SIDE ENTRY WITH RIGHT REAR EXIT
OPTION "D"

STORE # 11562

APPROVED WITH CONDITIONS

2008 PROTOTYPE CRITERIA SET PLAN "D" - ADDENDA RELEASE 5/19/08

NEW ELECTRICAL
PANEL CRITERIA
FOR THREE PHASE
400 AMP SERVICE

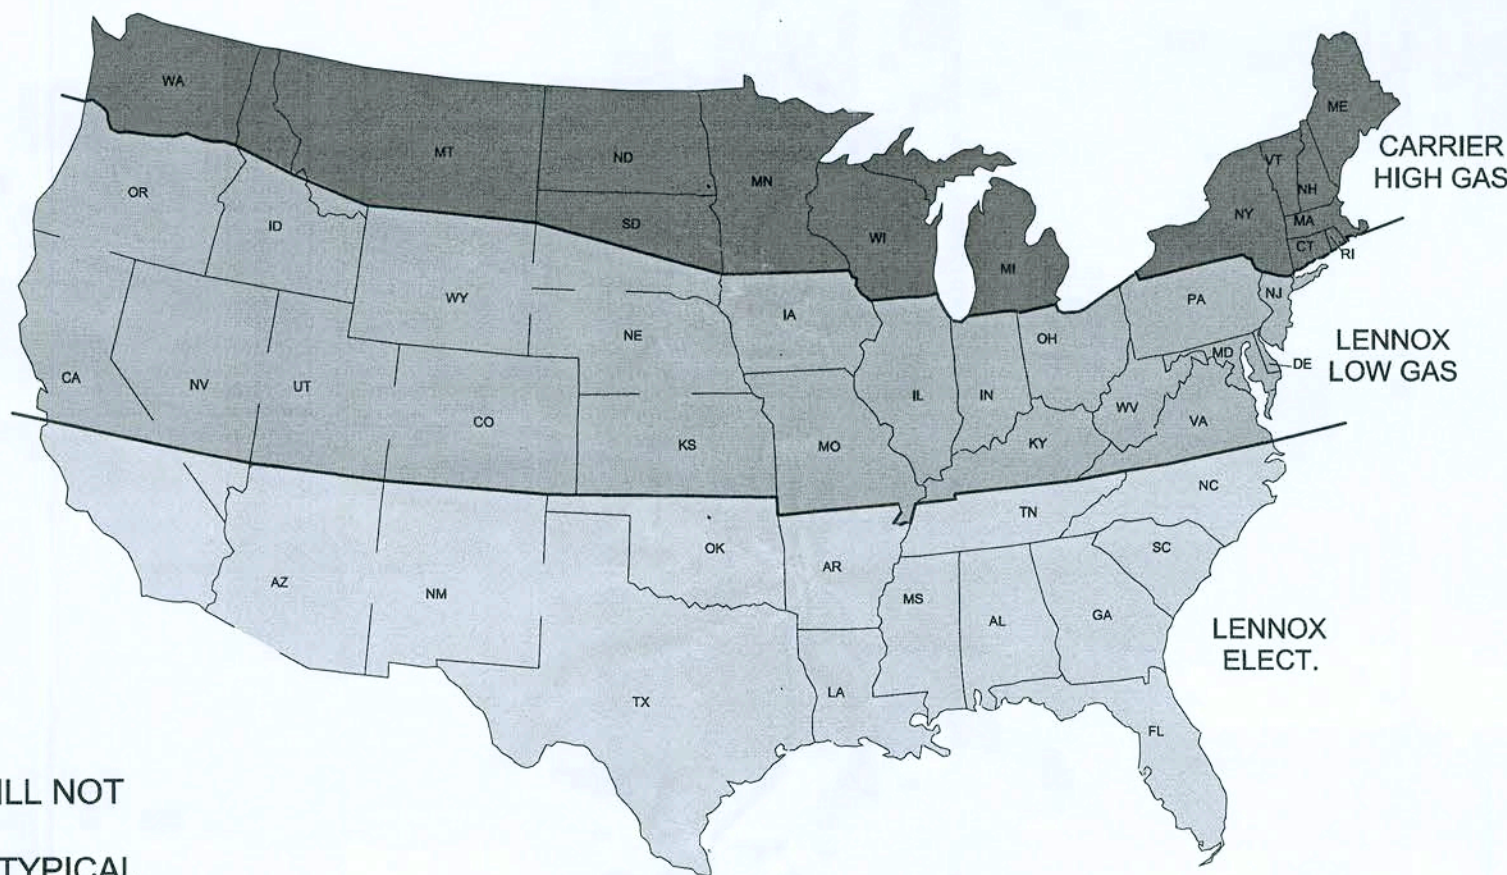
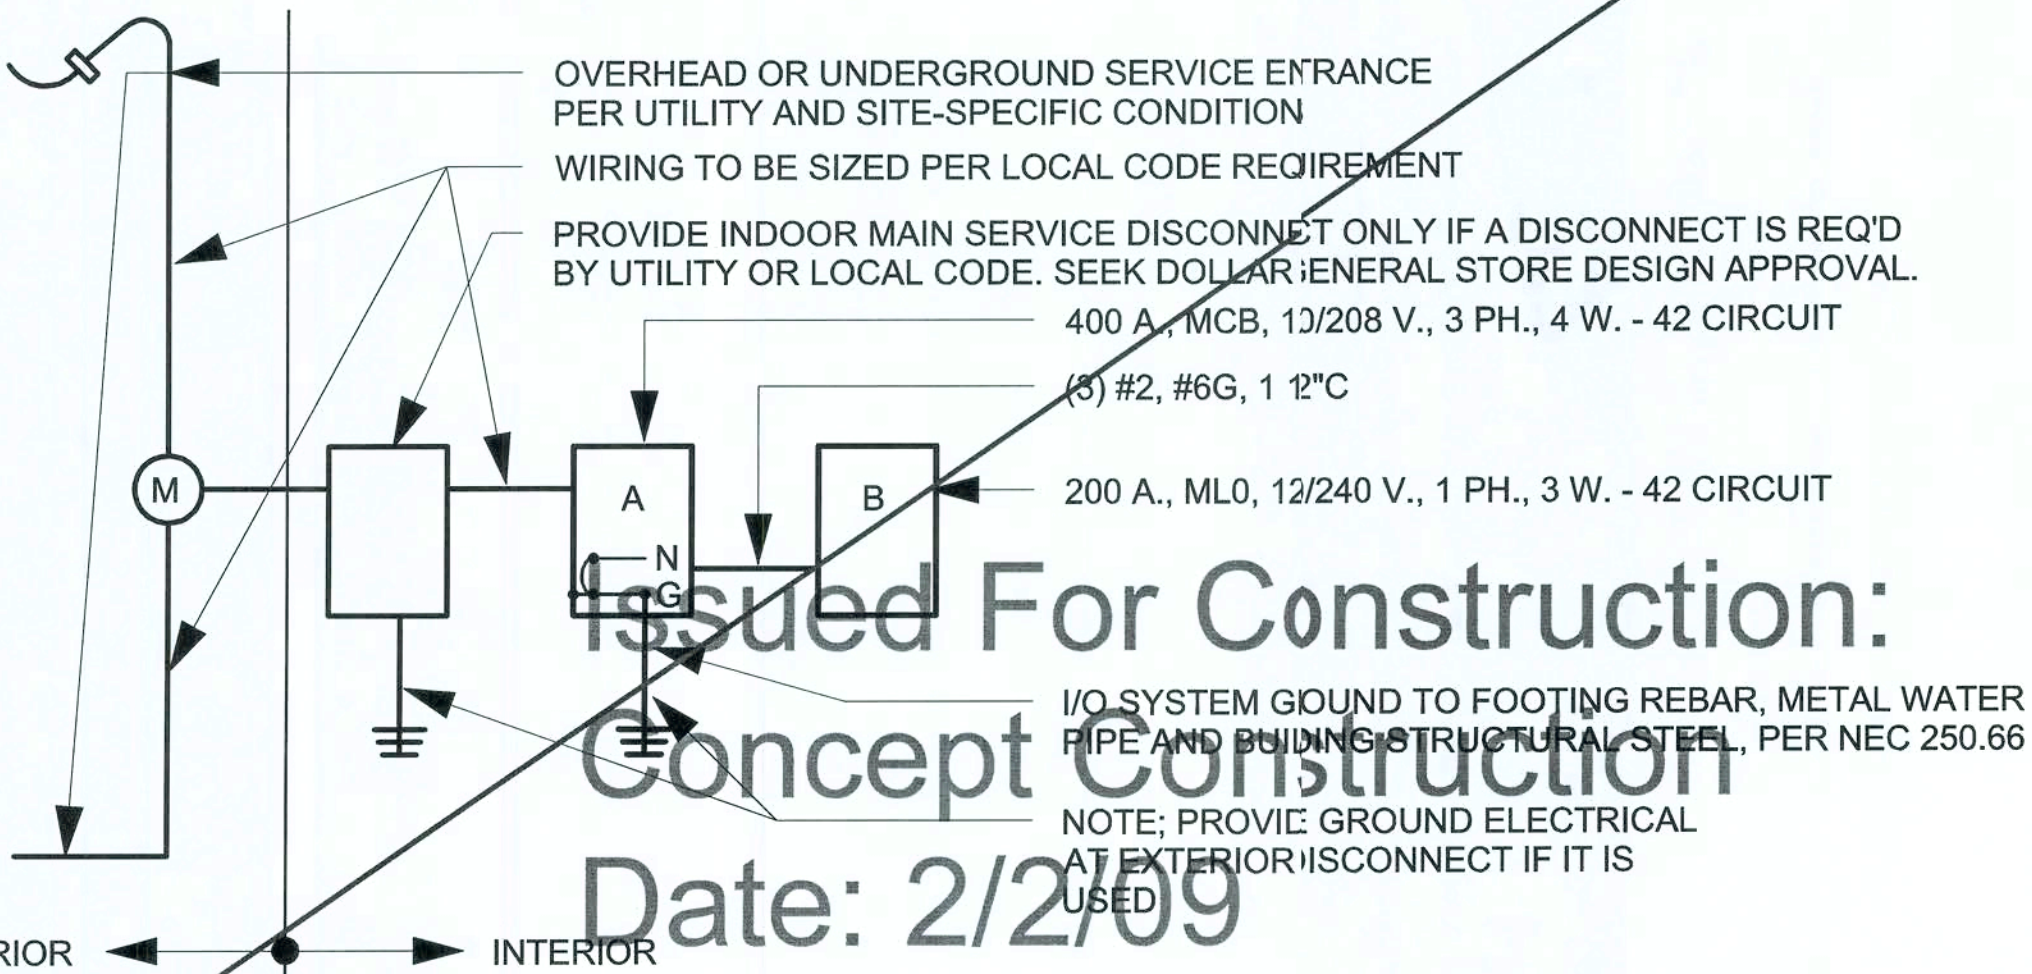
USE ATTACHED UPDATED
SHEET E.5 DATED 11.13.08

1 HVAC LAYOUT
1/16" = 1'-0"

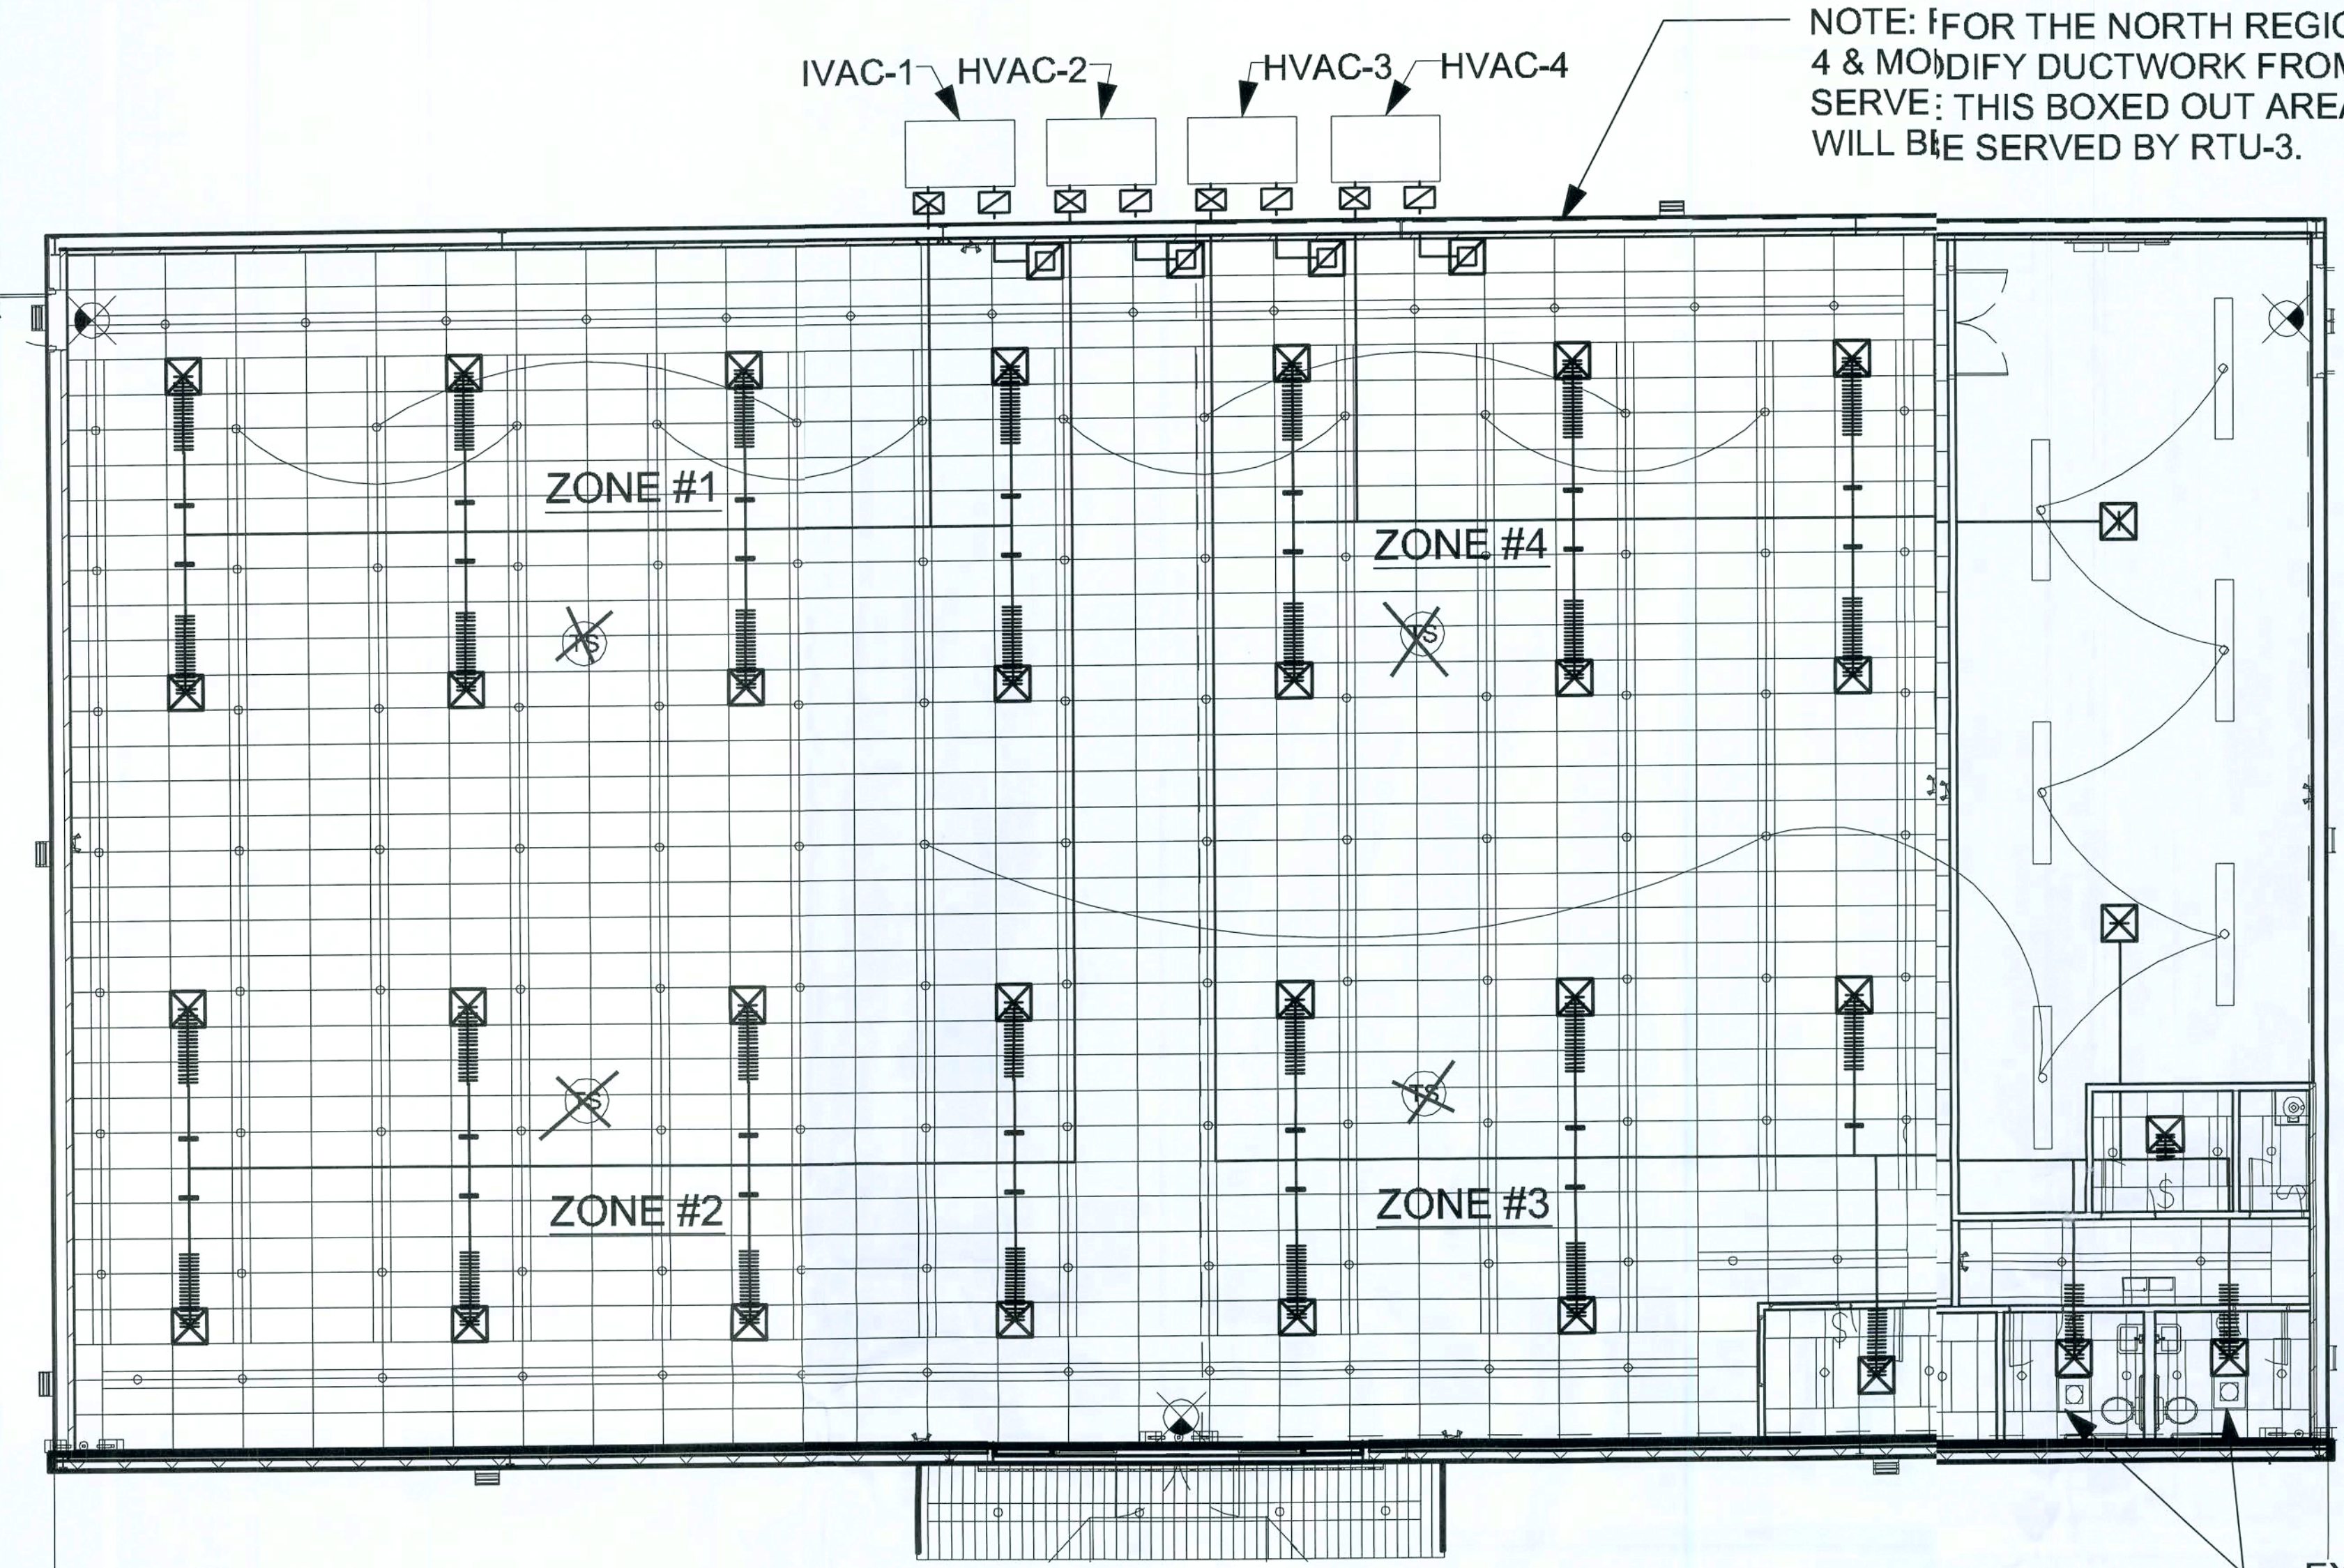
REFER TO ATTACHED E.5.
USE (4) 5; TON LENNOX
KCA060S4BN UNITS
